Subject: Geometry overlaps!!!!

It seems that there is a lot of problems in the Panda geometry which cause the simulation to crash specially when using new packages of ROOT and VMC (ROOT 5.23.2, Geant4.9.2.p1, etc). I attached to this mail 2 root files with:

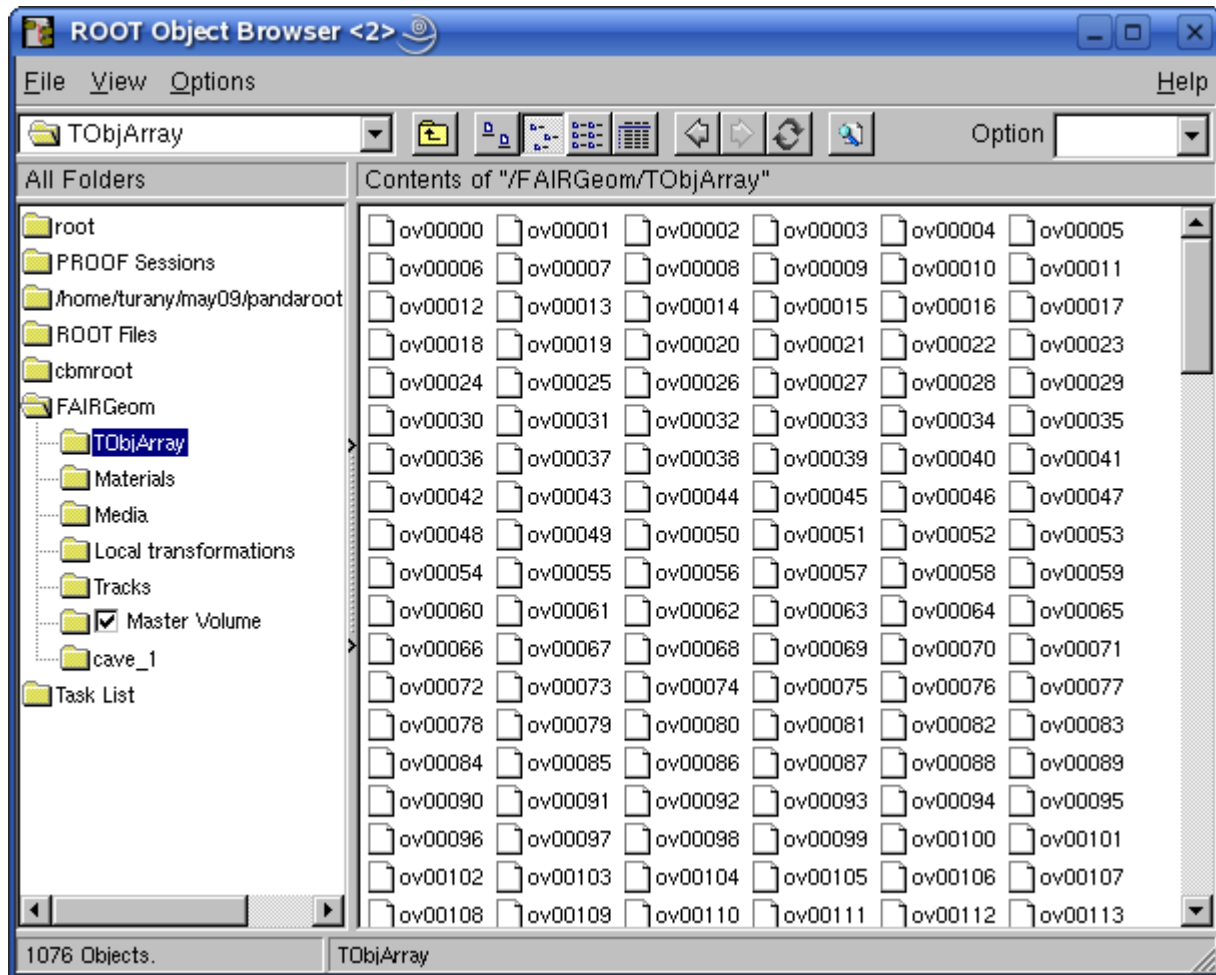
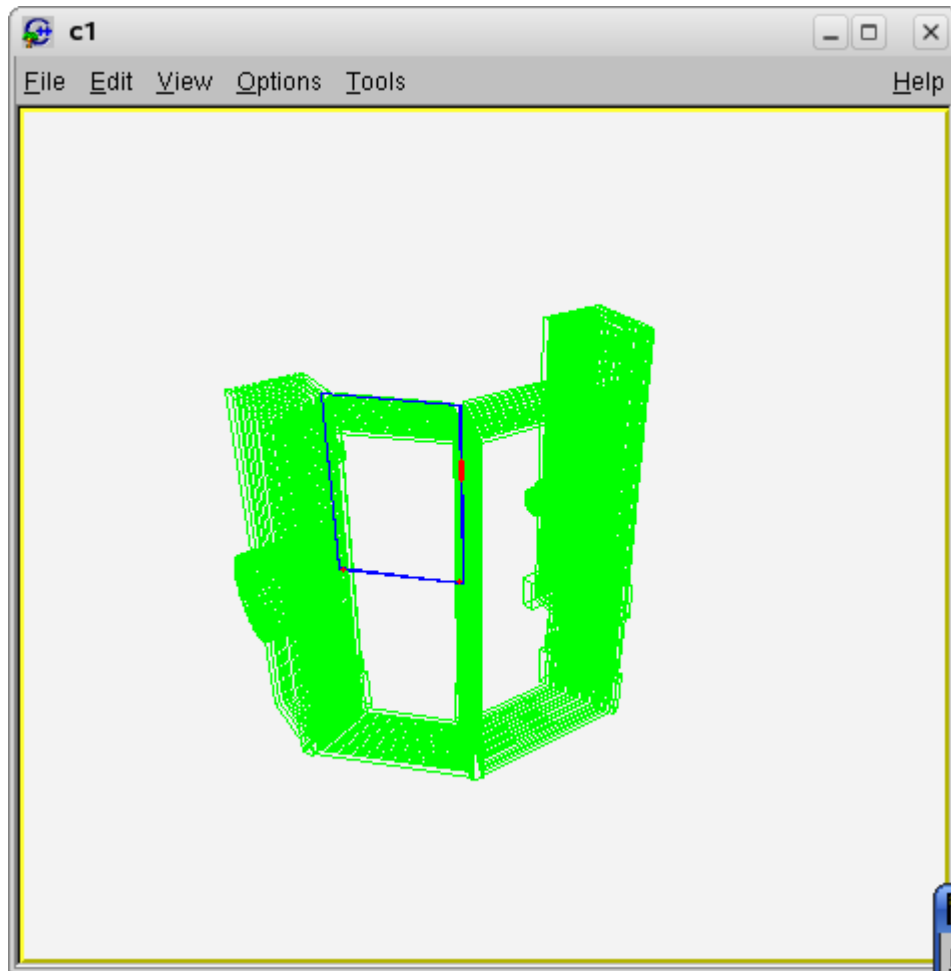
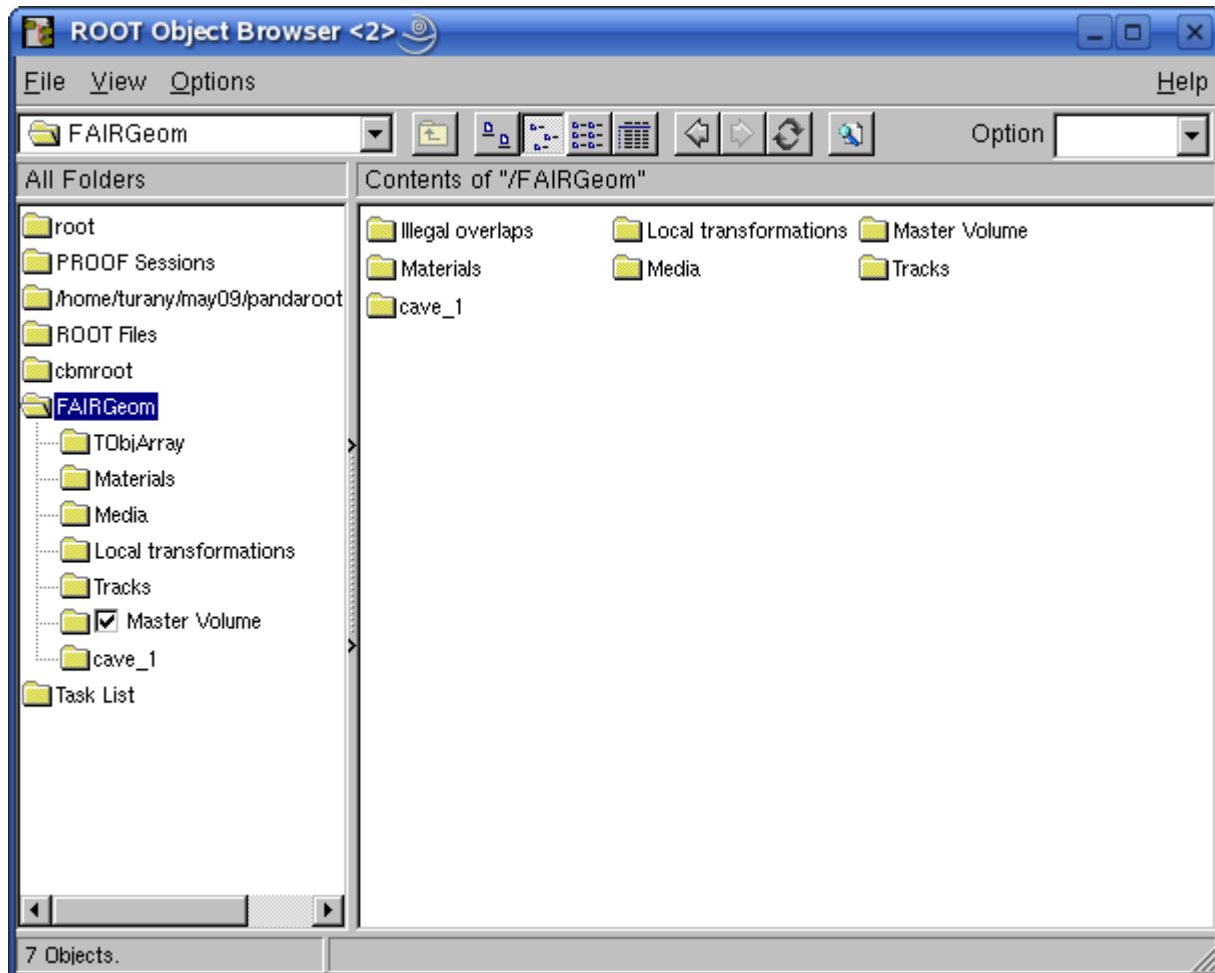
in this file you will see 447 overlaps! mostly between MDT and Soleniod

the same as before with the PandaSolenoidV833.root as geometry file for the Soleniod. This has also 538 overlaps!

With this geometry as it is now it is almost impossible to run any simulation! I will try to investigate if this has anything to do with the new packages but please take a look also to the overlaps and check your detectors if the geometry is really correct!

Please check this, most of them are small overlaps which could be avoided by using better precision!

As far as I know, the mdt geometry inside svn is an old one with overlaps, and it was never updated for the new solenoid design.

For this reason I would suggest to skip mdt from the global sim macro, waiting that the geometry is fixed.
